ADDENDUM NO. 1

Reference: Stewart Stadium Field Renovation
WSU - Ogden, Utah

Project No.10280810

Addendum No. One
for the
STEWART STADIUM FIELD RENOVATION
WEBER STATE UNIVERSITY
DFCM PROJECT NUMBER 10280810
MHTN Project No. 2010575.00

Sheet No.
AD01-L02

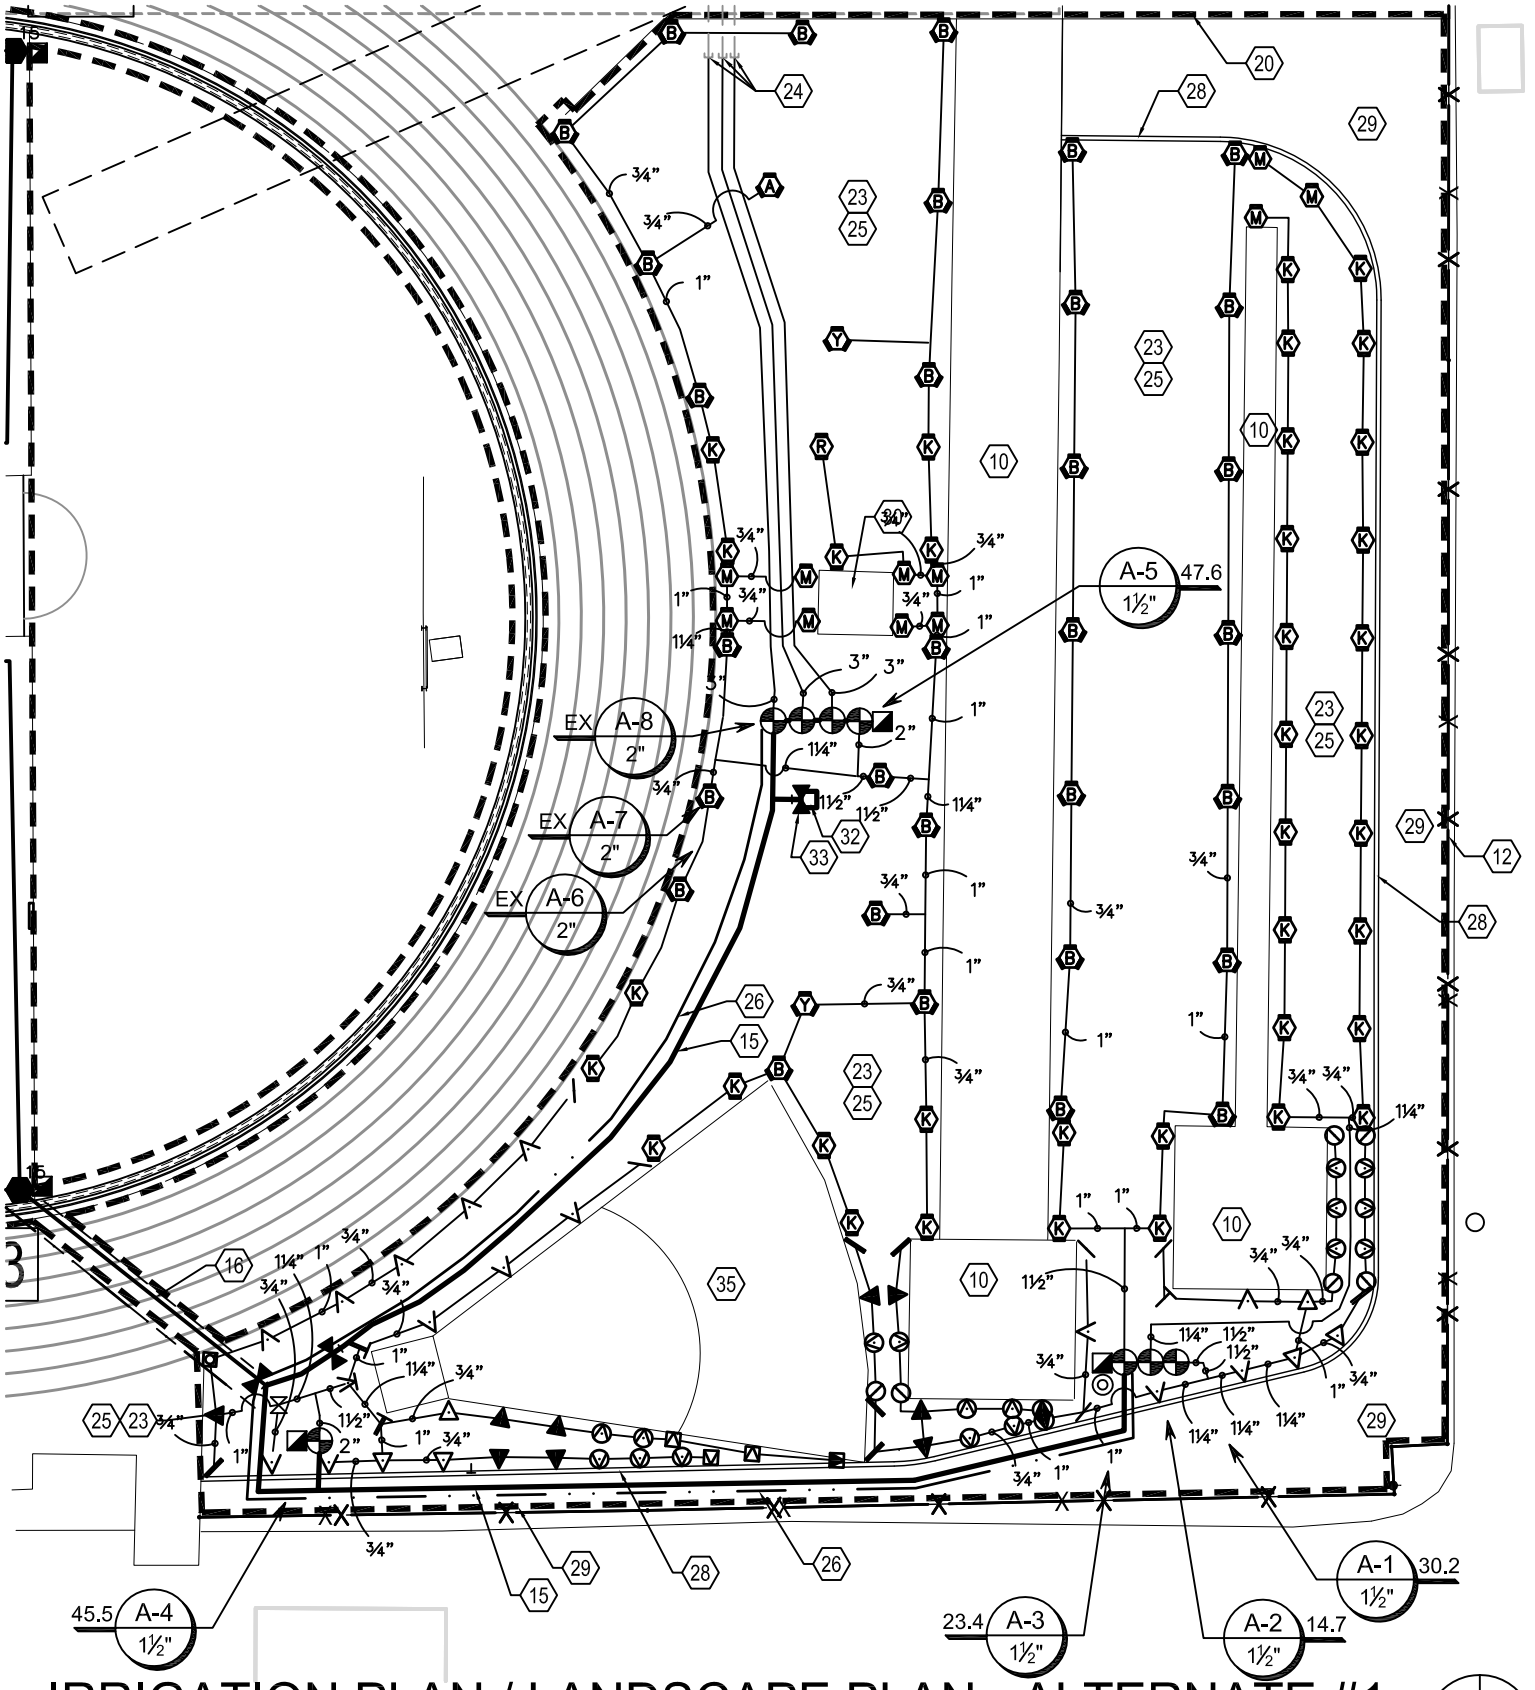
c. The removal of sod, topsoil, the existing irrigation system and installation of concrete mow strip, irrigation, topsoil and sod shown in the south track event area shall be part of **Bid Alternate #1**. See AD01- L02.
